DRAWN rnorthrop	6/16/2014	University of Chicago		
CHECKED M.B.				
QA		F T K Front Panel Detail		
MFG				
APPROVED		SIZE C	DWG NO AtlasFrontPanelRevG	REV G
		SCALE	SHEET 1 OF 1

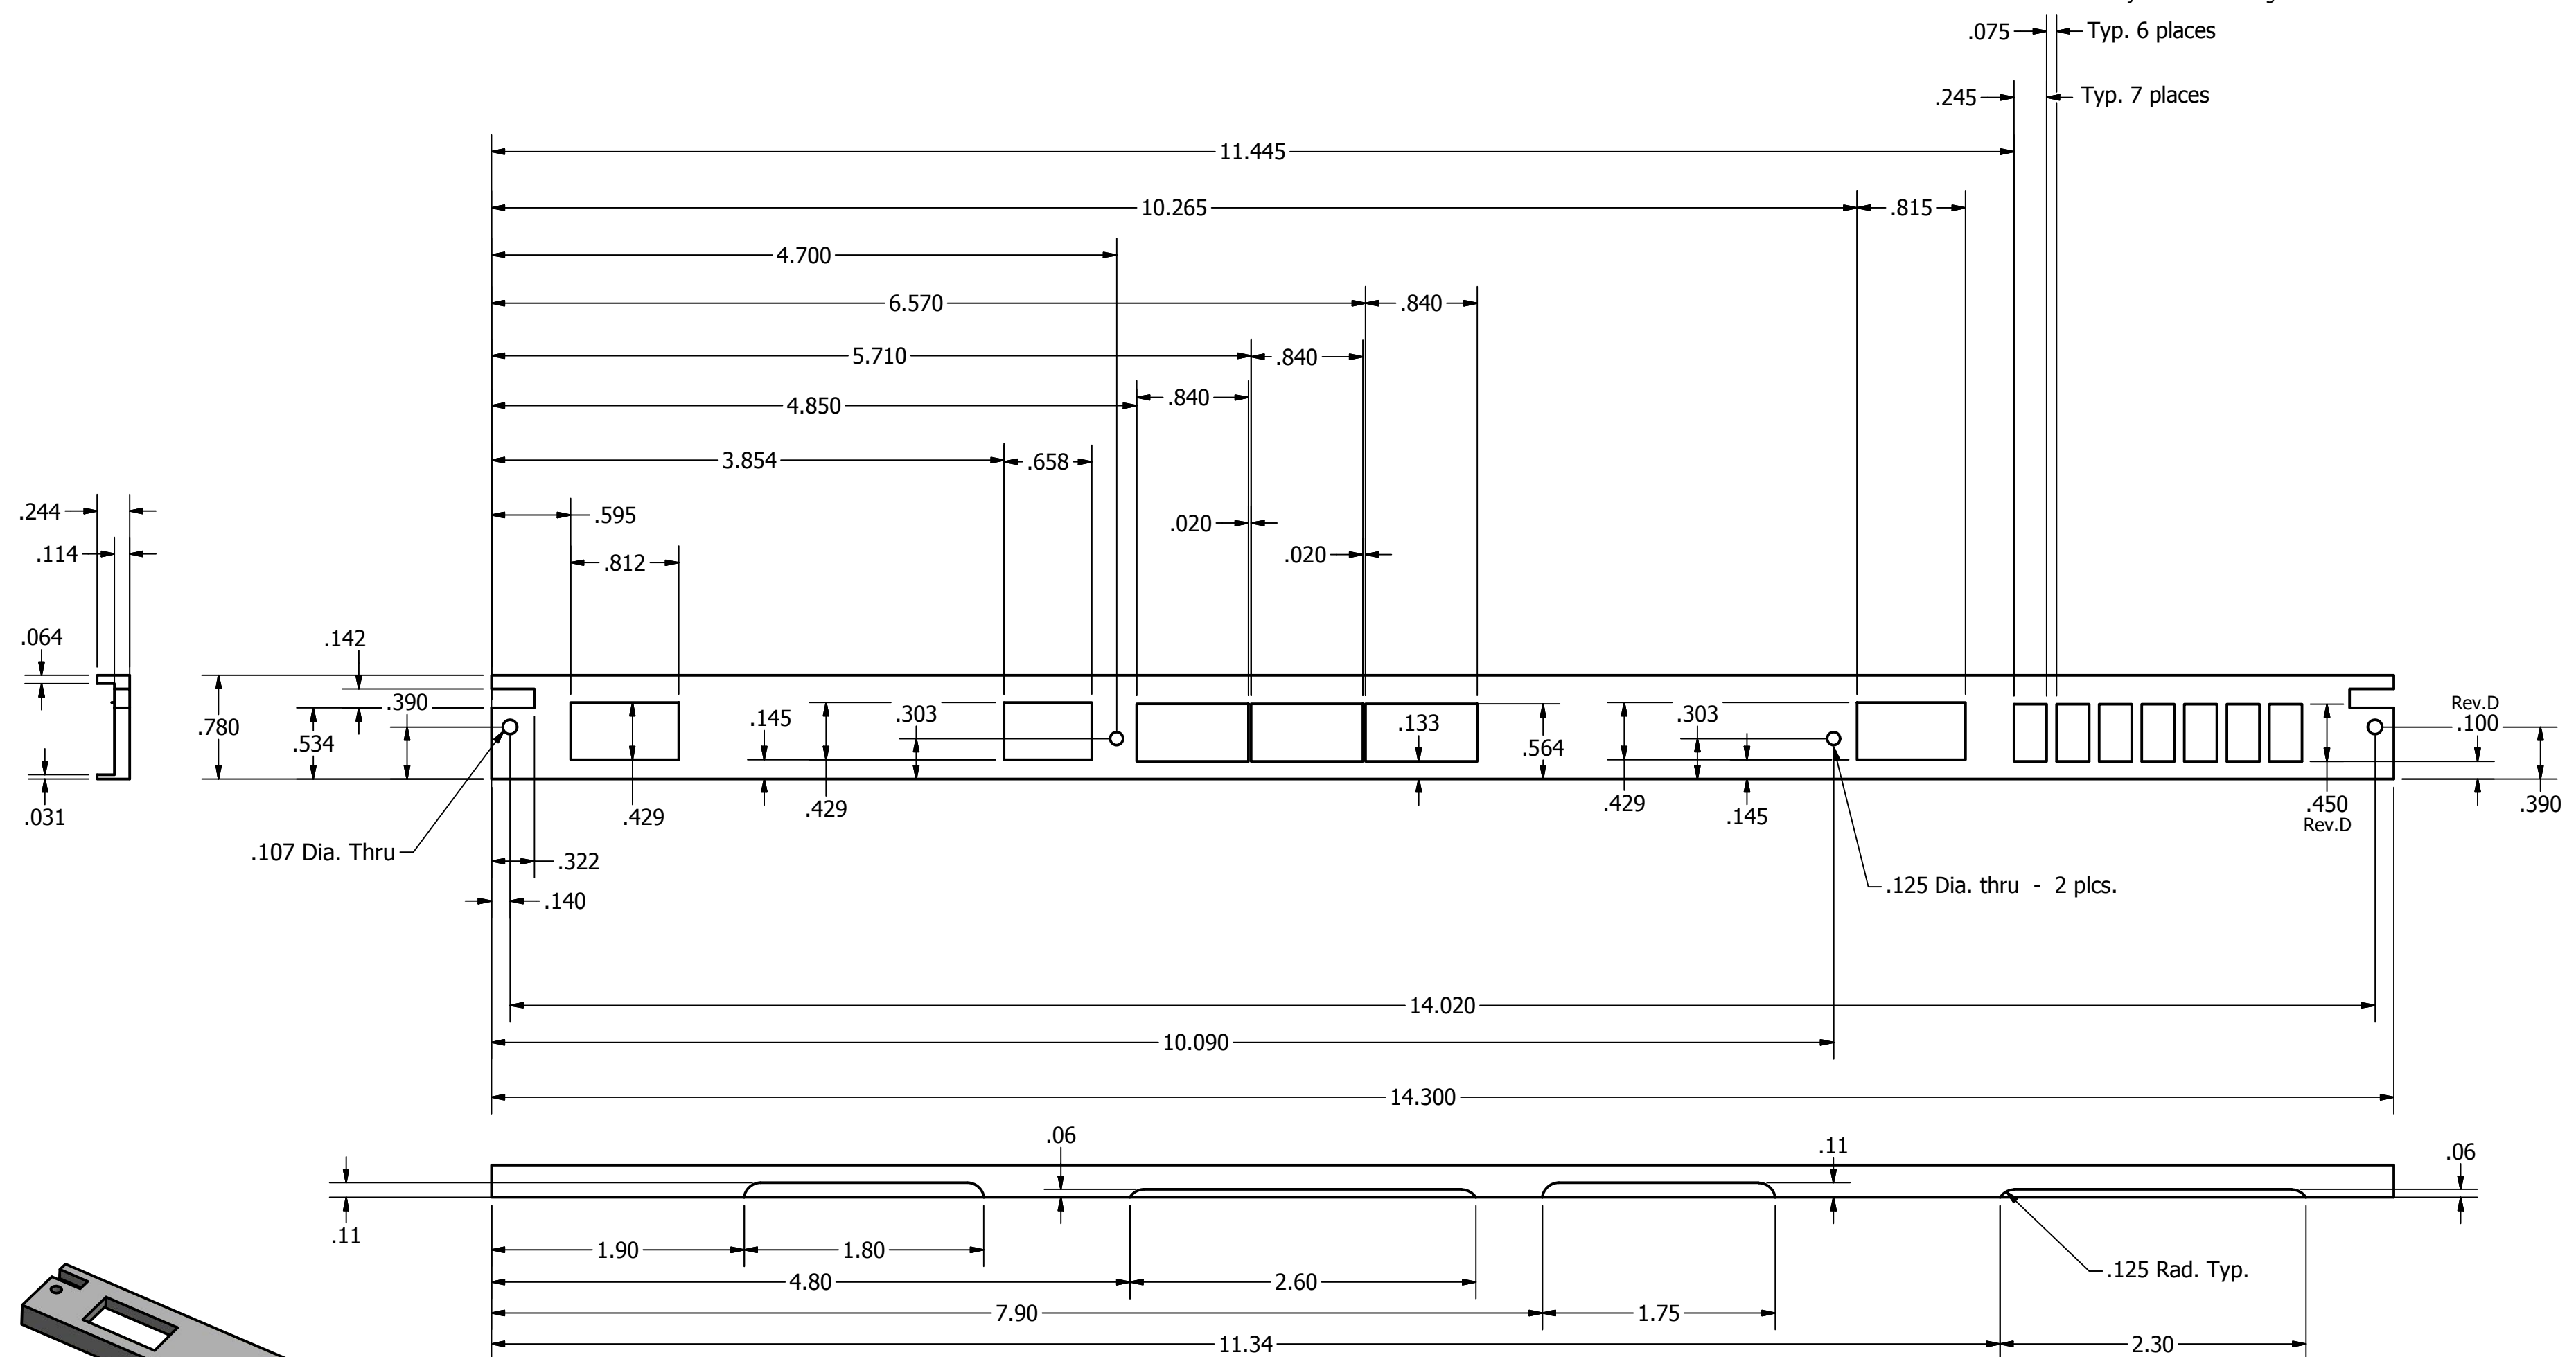
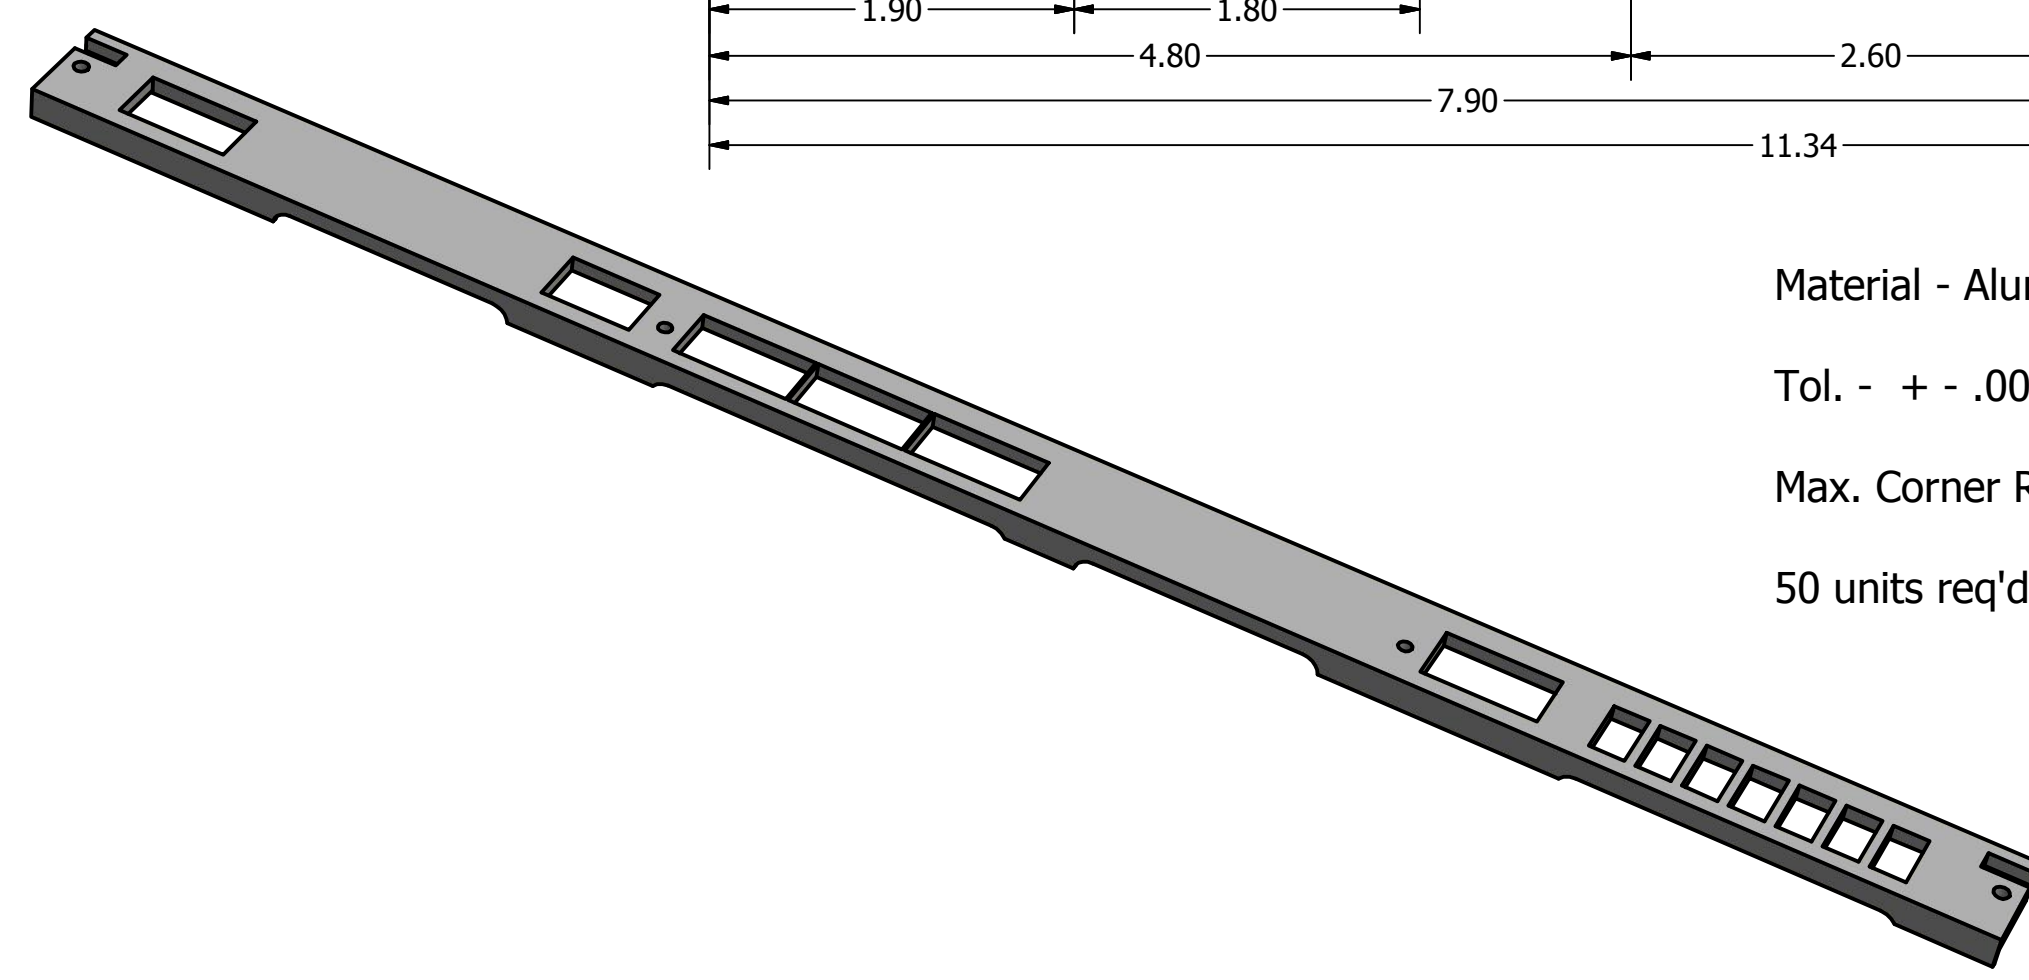
Rev. A Major Revision 8.5.14 RN
 Rev. B All openings enlarged slightly 4.17.15 RN
 Rev. C Backside extrusion removed 5.12.15 RN
 Rev. D LED openings enlarged (indicated) 7.23.15 RN
 Rev. E Hole dia. for mount blocks inc. from .096 to .125 11.1.16 RN
 Rev. F Edge slots added 11.7.16 RN
 Rev. G Major revision to edge slots 11.9.16 RN
